**Bylong Coal Project (SSD 6367)
Response to IPC Request for Additional Information**

This document provides the requested advice / information in relation to the five issues raised within the IPC's correspondence for review and consideration by DPE. This document also provides an appropriate response to the submission (and presentation) from Mr Doug Anderson of the University of New South Wales Water Research Laboratory (UNSW) (commissioned by the Environmental Defenders Office (EDO), on behalf of the Bylong Valley Protection Alliance (BVPA)) which make invalid assertions in relation to the modelling and assessment which warrant a response.

Bylong Coal Project Response to UNSW Submission on Bylong Groundwater Assessment

FIGURE No:
1

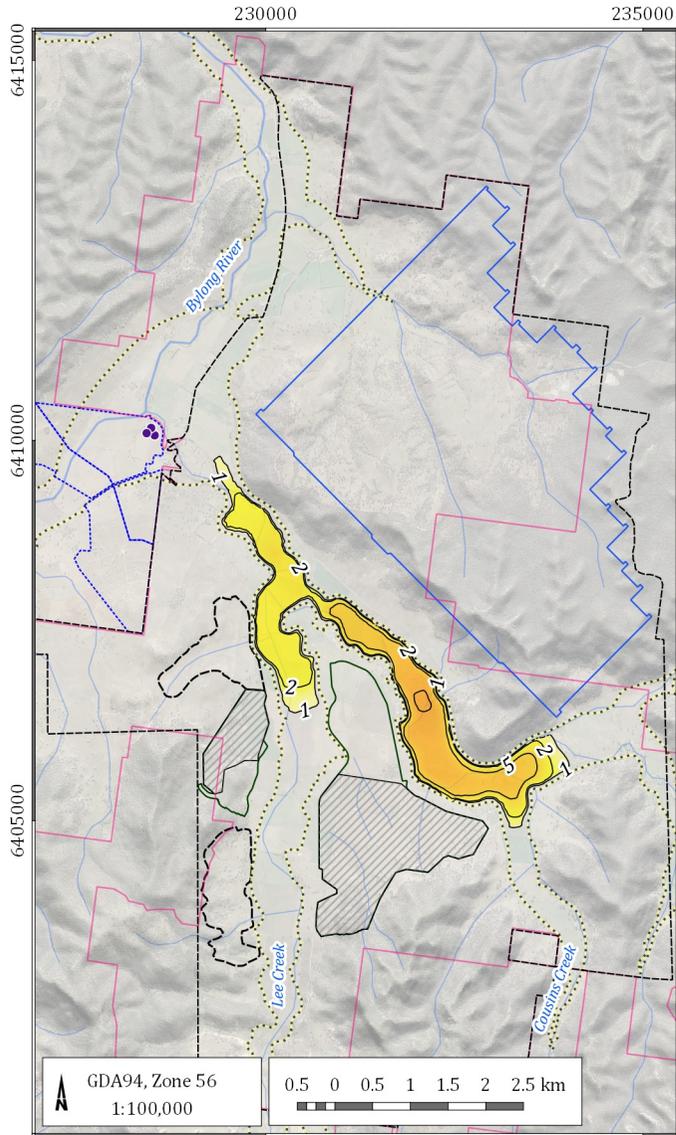
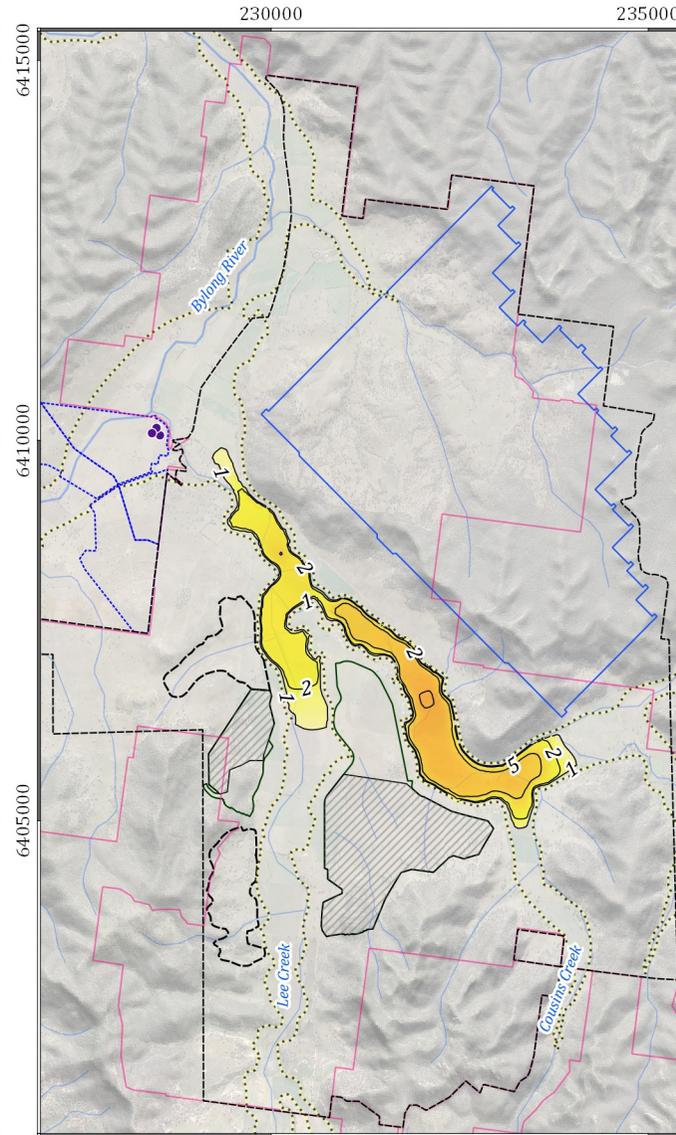
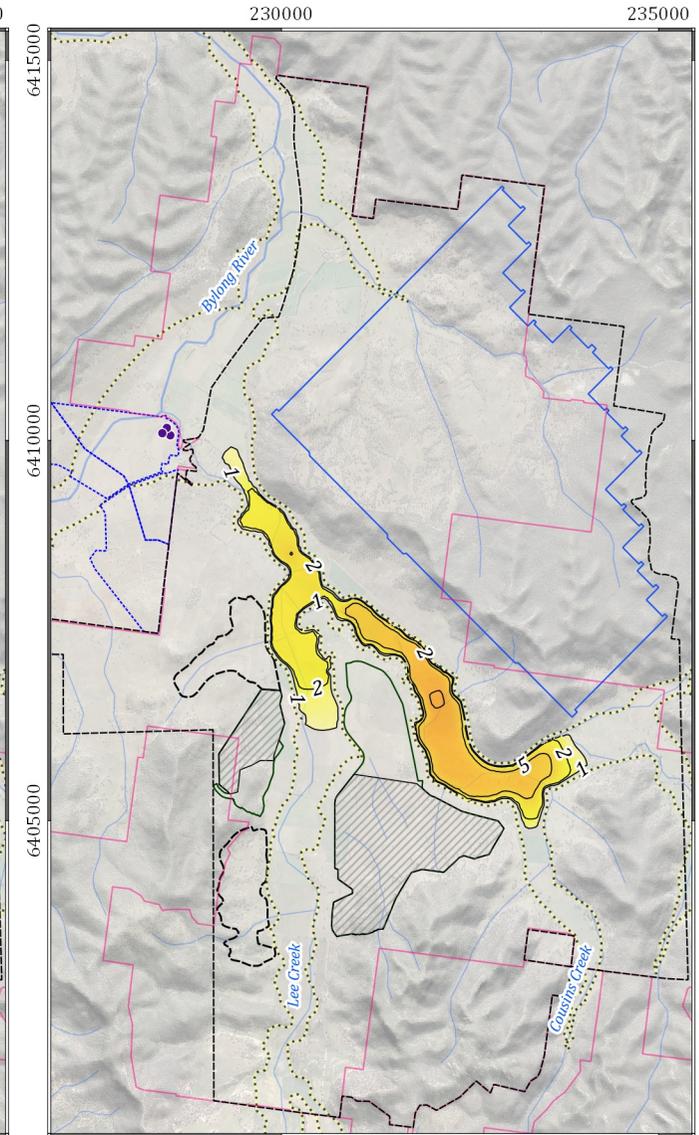
Anderson (2018) conducted simplistic modelling to show the influence of specific storage on predicted drawdown in a sand aquifer. The modelling represents a confined sand aquifer system. This is not an appropriate assumption as the alluvial aquifers at the Project are not confined. The results of this modelling therefore should not be applied to the alluvial aquifer occurring adjacent to the Project. This model predicts drawdown extending over 12 km from the pumping bore over time. These predictions from a hypothetical confined aquifer are completely inconsistent with actual observations from pumping test bores at the Project site which recorded very limited drawdown and results consistent with unconfined aquifer conditions where specific storage does not apply.

Anderson (2018) notes the uncertainty in the specific storage parameter by concluding that the issue of appropriate values of specific storage can only be resolved by *"further data collection and recalibration of the predictive model to determine more appropriate choices of hydraulic conductivity and recharge using realistic, measured values of specific storage"*. Specific storage is best measured directly via field tests that induce drawdown in surrounding strata and can be used to calculate the volume of water released from storage. Whilst this type of testing has been successfully undertaken in the alluvium for the Project, it is very difficult to implement in low permeability rock strata which occur at Bylong, as the rocks do not yield large volumes of groundwater amenable to pumping. The best data set for estimating specific storage remains bores adjacent to mines that have recorded drawdown due to mining and can be used to estimate specific storage through model calibration. Again, as the Project is a greenfield site, this information is not available.

Given the concerns raised over using appropriate values of specific storage, the numerical model was used to further investigate the influence of the specific storage range identified by Rau et al (2018) on model predictions. Two additional model runs were conducted, firstly where the specific storage in all model layers was not allowed to exceed an upper limit of $1.3 \times 10^{-5} \text{ m}^{-1}$, and secondly where the specific storage was set at the lower bound in all model layers of $2.3 \times 10^{-7} \text{ m}^{-1}$.

The maximum drawdown predicted by the model to occur within the alluvial aquifer for these cases is shown in Figure 1 below along with the base case results. The figure shows how changing specific storage to remain within the ranges identified by Rau et al (2018) has very limited influence to the maximum drawdown occurring within the Quaternary alluvium. This is because the model employs unconfined storage (specific yield) properties across the majority of layer 2 and layer 3. More depressurisation is predicted within the Permian bedrock when storage values are reduced, however this is of no consequence as it is not a significant water source within the region, and there are no flow on effects to the alluvium.

This sensitivity analysis of specific storage highlights that uncertainty in this parameter does not have significant flow on effects for the main receptors being bores within the alluvial aquifers. Therefore, the conclusions of the EIS and the associated measures to manage groundwater impacts from the Project are appropriate.
